SUBJECT AREA: Routing, None

REFERENCE: MCWS MMTP IR No 1

REFERENCE: CEC MMTP Round 1 IRs - Part 1

Map CEC-IR-011

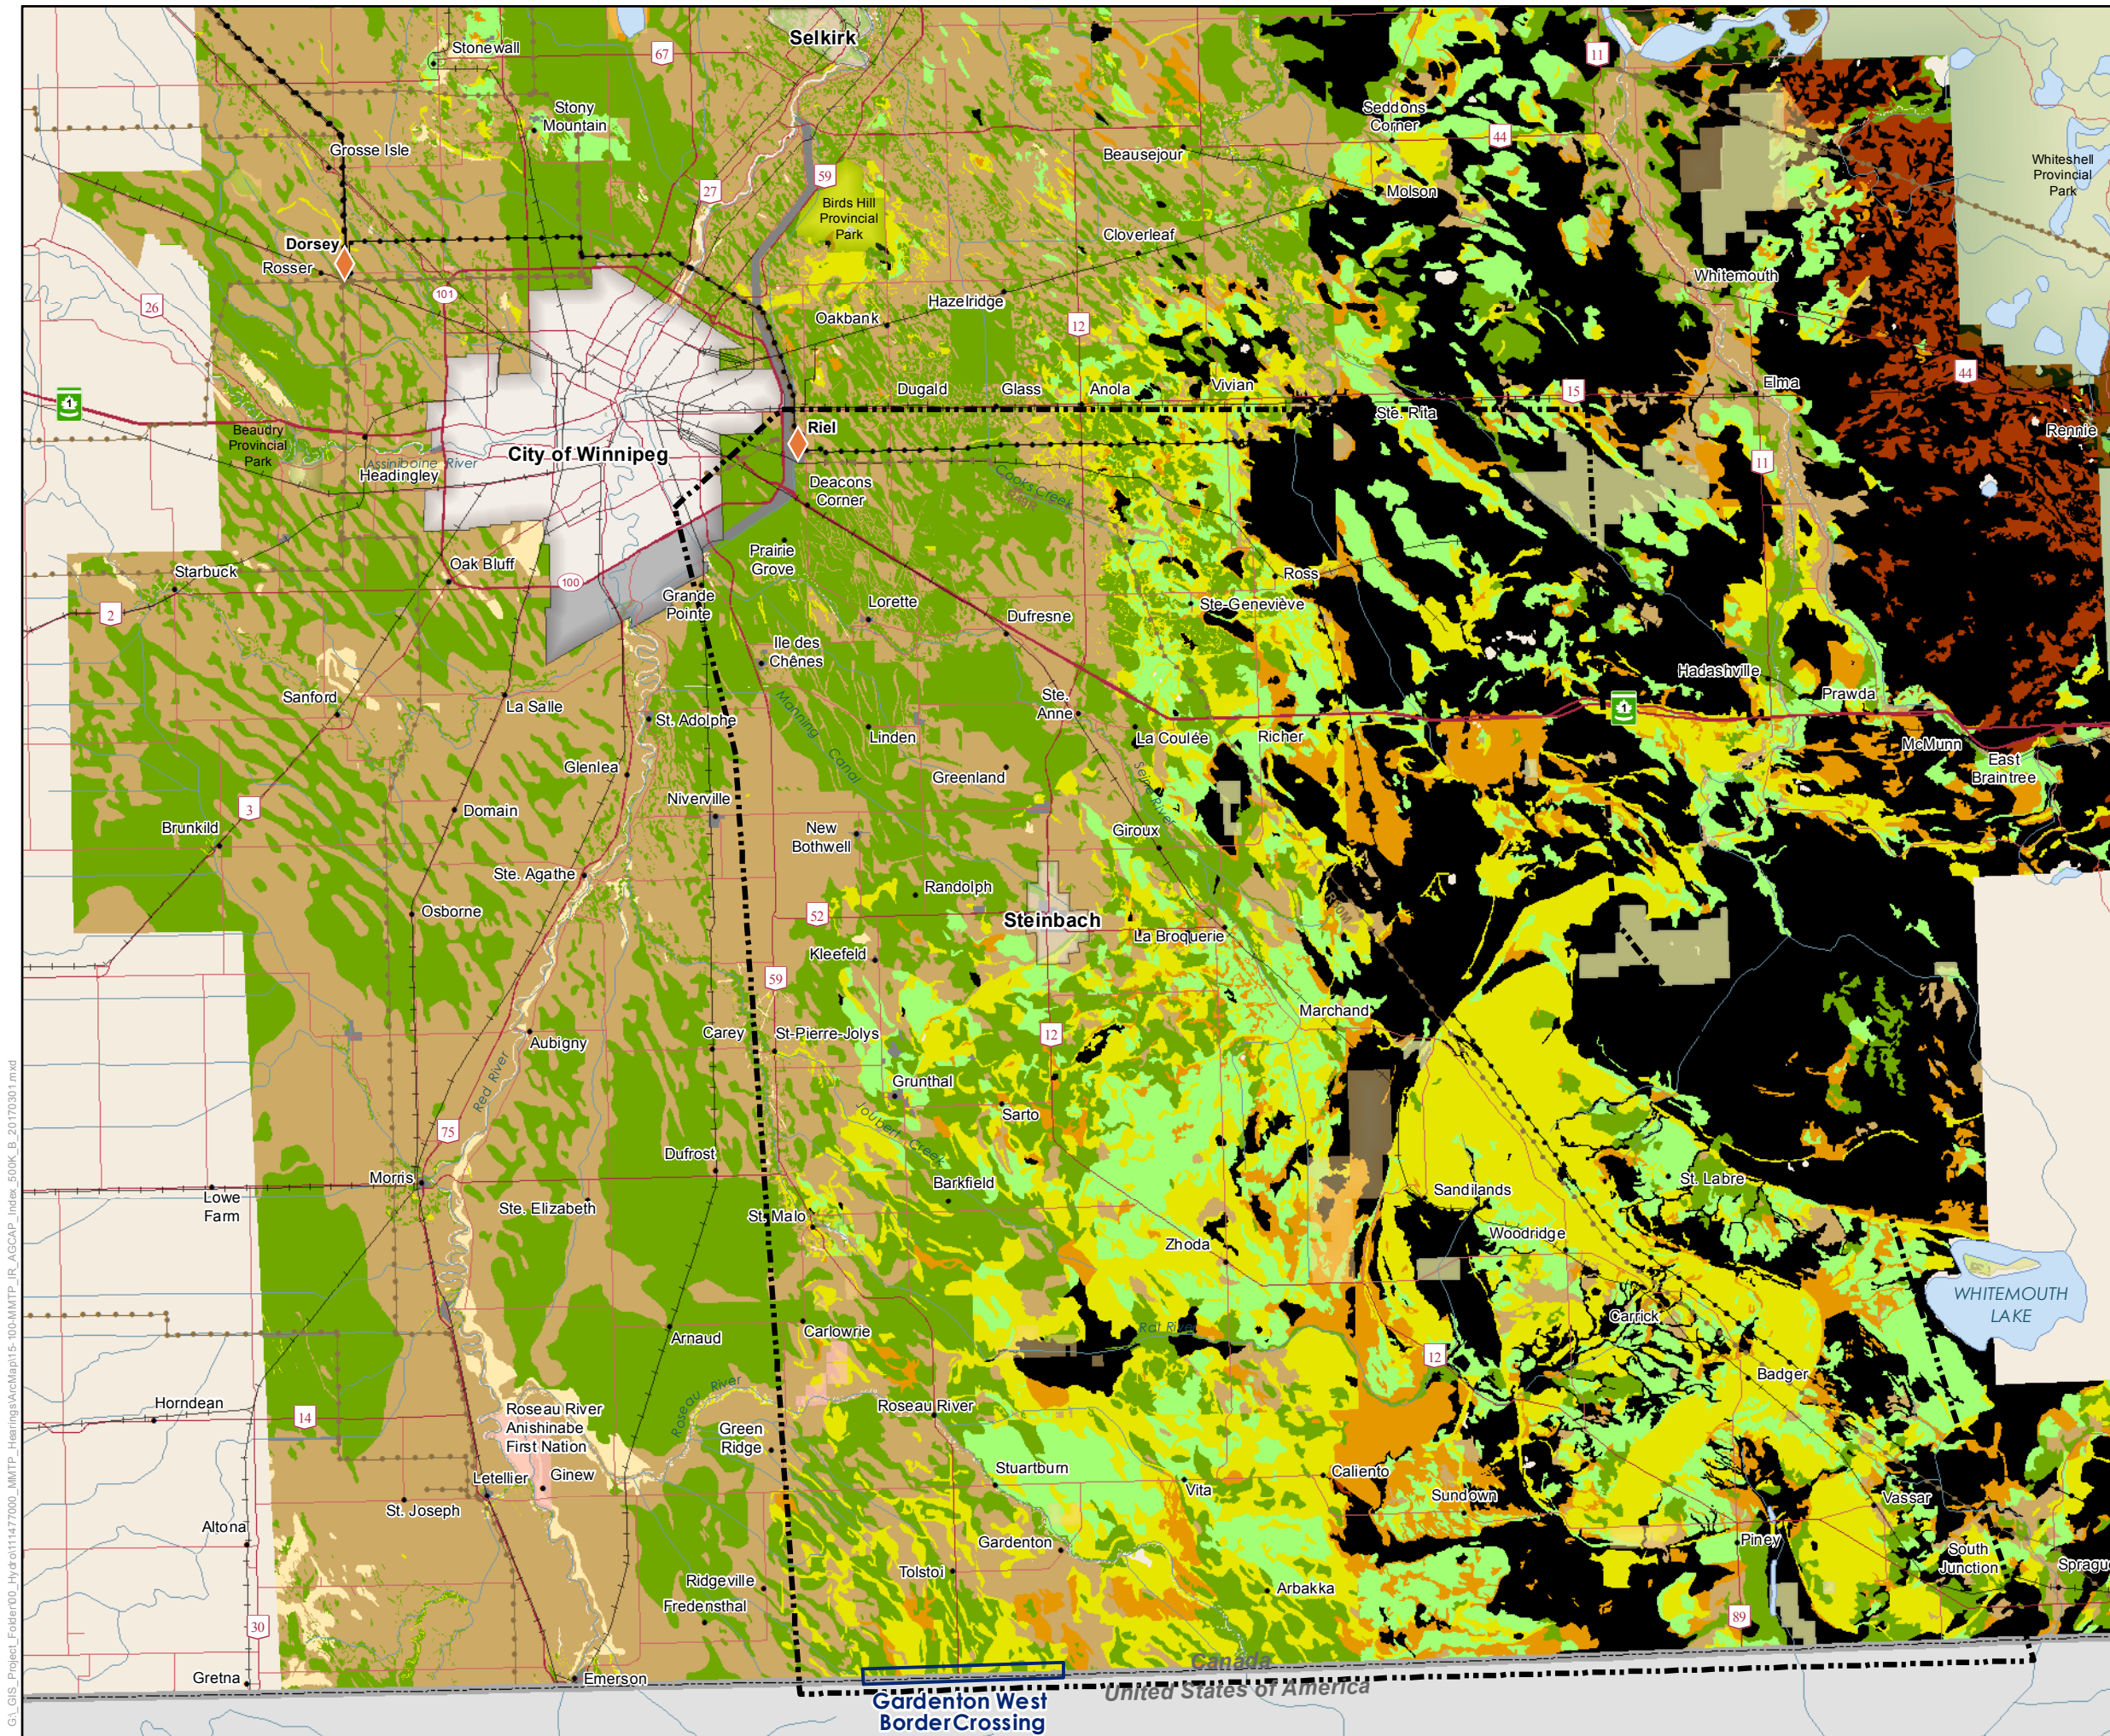
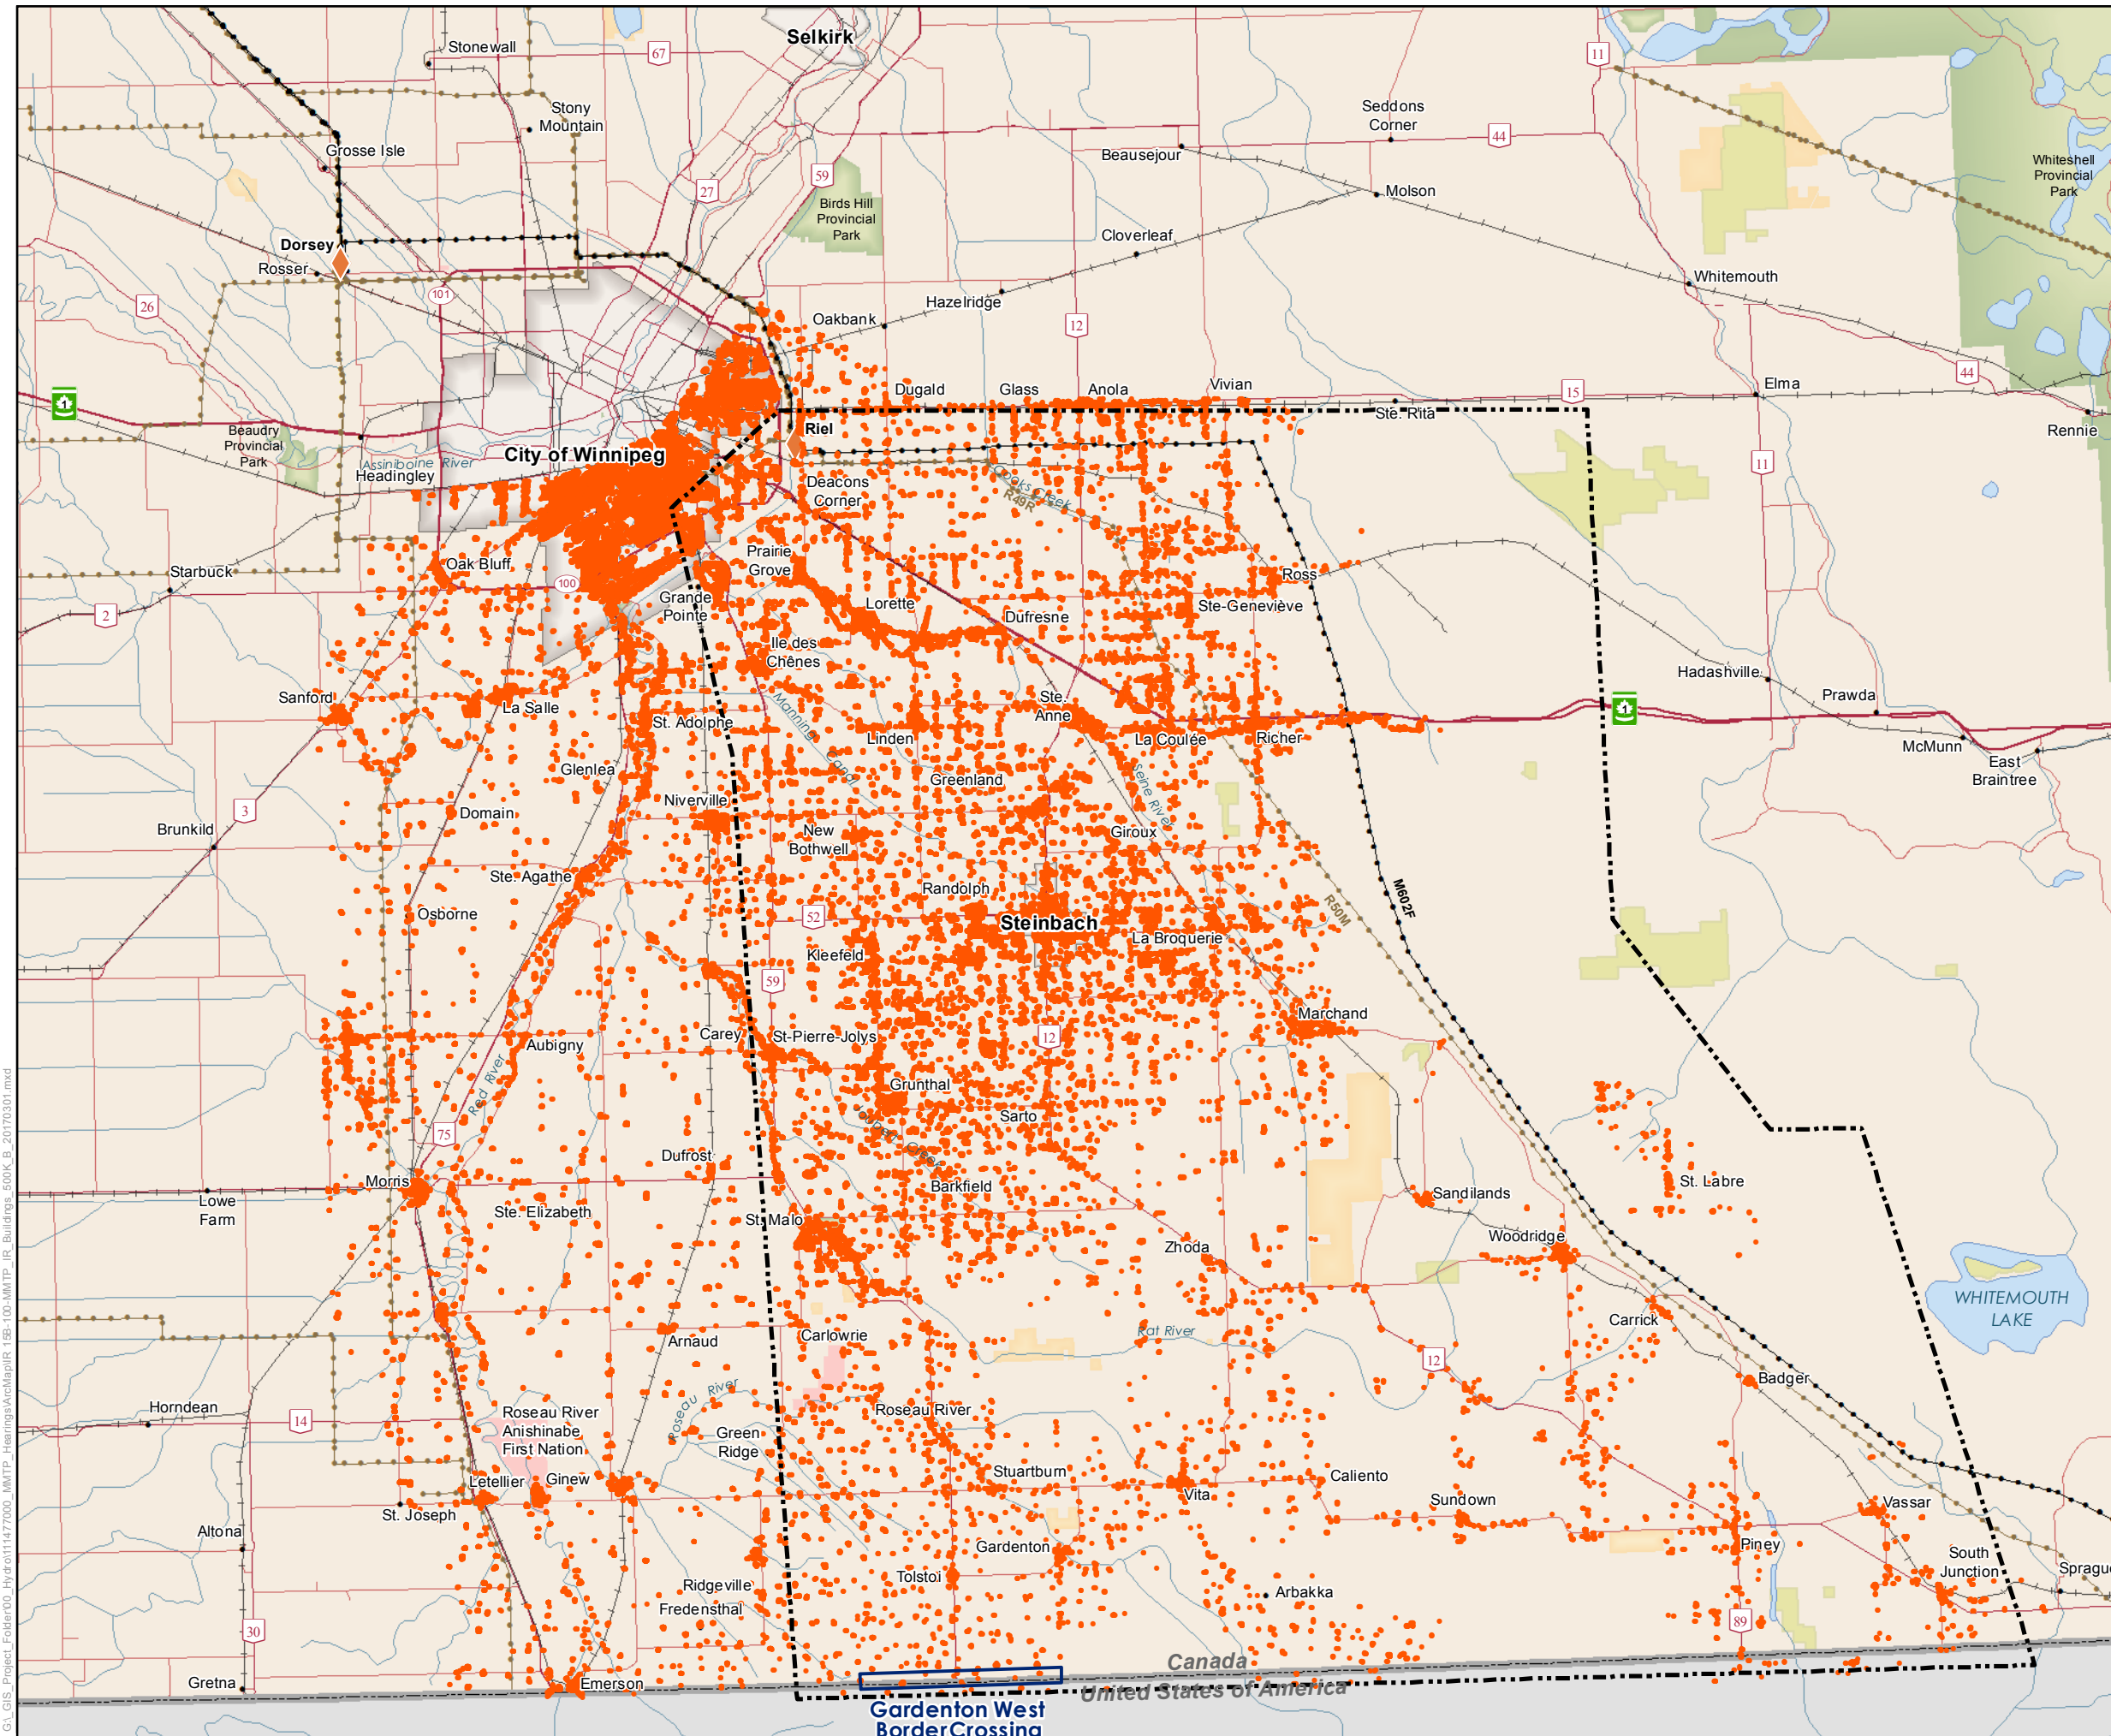
At the beginning of Section 5.3.2, it is explained the MMTP transmission line preliminary planning area and route planning area differ in area. The route planning area used EPRI methodology while in Section 5.3.1 to determine potential border crossing from Dorsey, a preliminary planning area was determined based on various transmission system concepts and a constraints and opportunities exercise using a list of criteria identify in Table 5-2.

It appears that this is perhaps best understood by examining Map 5-4 which shows both: the route planning area as well as several macro-corridors generated by the EPTI-GTC approach. This shows that one of the macro corridors lies outside of the Route Planning Area and is generally aligned immediately south of Winnipeg towards the US border. Is this interpretation correct?

If the EPRI-GTC approach generated a macro-corridor outside of the Preliminary Planning Area this would seem to quantitatively demonstrate that the macro corridor directly south of Winnipeg represented a viable option for further consideration (based on the criteria established during the macro corridor planning exercise). It also would seem to be counter-intuitive to the EPRI-GTC approach which indicates the macro corridors are identified before the study area is selected. Because the approach and model will select the shortest route when all factors are considered equal and that the longer a route is the more expensive it is as well as potentially disrupting more social and environmental factors one can understand why a macro corridor south of Winnipeg to the US border would have been likely generated.

Finally, please explain the order in which the separate planning process for the route planning area and macro corridor generation development process occurred. Did these two processes occur concurrently, semi-concurrently or did one occur before the other?

- 7 1. We did not consider an additional border crossing to the west of Gardenton West
8 (directly south of Winnipeg).
- 9 2. In the EPRI-GTC Methodology, macro corridors are used to help define the study area
10 for more detailed data collection. Manitoba Hydro had already completed detailed data
11 collection in the area to the west of the Route Planning Area as a part of the St. Vital to
12 Letellier project. On this project we determined that the Macro Corridor identified to
13 the west, which parallels the existing Y51L transmission line, was deemed unsuitable for
14 future consideration due to the extensive length within the Red River Floodplain,
15 existing and expanding wind farms and residential developments adjacent to the
16 existing ROW.

- 17 3. As noted in the question and the EIS, Chapter 5, Section 5.3.1 the rationale for the
18 Western Boundary was described on page 5-14.
- 19 *“The western boundary was delineated to limit the effects of transmission routing on the
20 various towns and communities located to the south of Winnipeg. The western boundary
21 was intended to limit transmission routing effects on development and urban
22 development extending immediately south from Winnipeg and cumulative effects on
23 agricultural land use with St. Vital Transmission Complex and Bipole III Transmission
24 Projects. The area adjacent to and west of PTH #12 also has higher density rural
25 residential development, more intense specialized agricultural land uses and developed*

28 As noted above, analysis conducted on the St. Vital to Letellier transmission line had
29 contributed to the knowledge of the location and extent of high value agricultural lands
30 and the locations and concentrations of homes and buildings in the area to the west of
31 PTH#12. The attached maps (Map CEC-IR-11 Agricultural Capability and Map CEC-IR-11
32 Buildings) provide a visual representation of this information and the location of the
33 Route Planning Area that was delineated from consideration of the macro corridors.

- 34 4. The sequence of events were:
- 35 a. St. Vital Project and related analysis and data collection
 - 36 b. Macro Corridor for MMTP,
 - 37 c. Establishment of Route Planning Area,
 - 38 d. Identification of Alternate Corridors,
 - 39 e. Elimination of Gardenton West,
 - 40 f. Development of Alternate Routes
